# **Record of Decision**

**Newland Island/Lock 4  
Dredge Spoil Disposal Area**

**Town of Schaghticoke - Rensselaer County  
New York**

**Site Number 442033**

# Figure 11

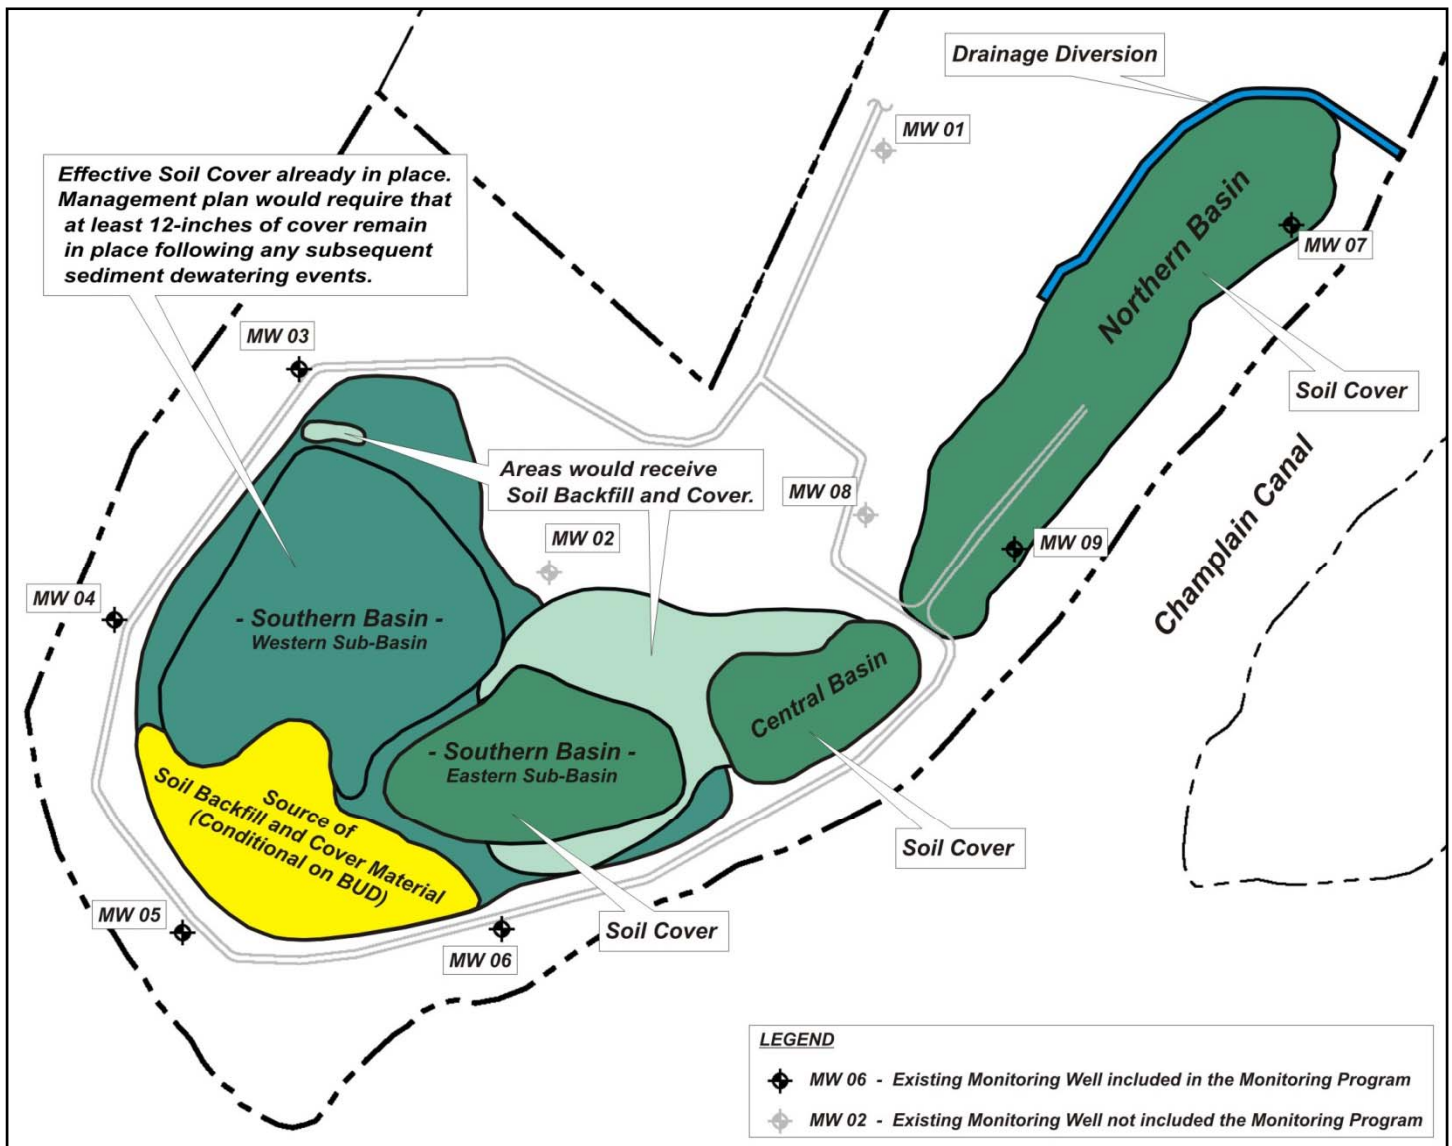
**COMMENT 4:** What is the purpose of placing a drainage diversion trench along the western side of the northern basin? Does the area west of the northern basin contain contaminated dredge spoil material?

**COMMENT 15:** After the proposed remedy is implemented, will the soil covers placed over the northern and central basins be mounded or graded to match the existing topography?

**RESPONSE 4:** The purpose of the drainage structure is storm water management. The area west of the northern basin does not contain contaminated dredge spoil material. The selected remedy includes the construction of a drainage diversion trench along the northwestern margin of the northern basin to intercept and redirect any intermittent overland storm water flow in this area and adequately impede/eliminate the migration of this water into and through the known dredge spoil

**RESPONSE 15:** The final soil cover over the central and northern dredge spoil disposal basins are to be graded to match the adjacent ground surface elevations to the extent practical and with no appreciable increase in footprint area. A slight pitch would also be incorporated into the cover grade to promote surface drainage toward the proposed drainage diversion trench along the northwestern margin of the northern basin.
